**From:** [Gwen Long](#)  
**To:** [Joobrien@cityofmadison.com](mailto:Joobrien@cityofmadison.com); [Fries, Gregory](#); [Board of Public Works](#)  
**Cc:** [Conklin, Nikki](#); [Crawley, Katie](#)  
**Subject:** Pheasant Branch Watershed Study survey  
**Date:** Monday, August 22, 2022 5:41:01 PM

How can we provide meaningful public comments when there is no Project Plan for the Sauk Creek Greenway Restoration in the August 1, 2022, 393 page, Pheasant Branch Watershed Study?

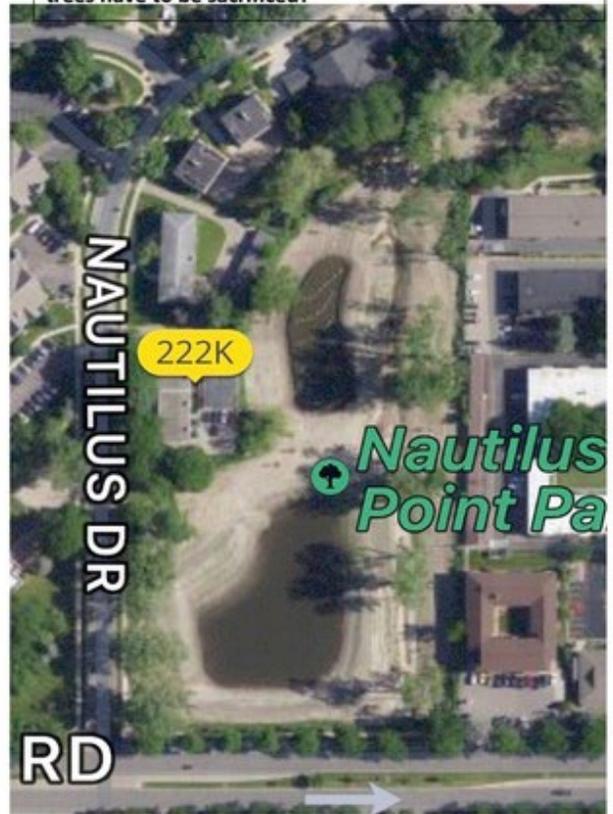
Before City Engineering "restoration" project, Beltline to Tree Lane

AFTER 2018 City Engineering removed 90% of trees, installed a one block raised concrete "Bike Path to nowhere". Now area is full of weeds.

This had been lovely wooded area.

BEFORE Nautilus Point Park, On Mineral Point Rd across from Oak Wood Village.

AFTER City Engineering "Restoration" put in 2 retaining ponds and removed 90% of trees. Why did so many trees have to be sacrificed?
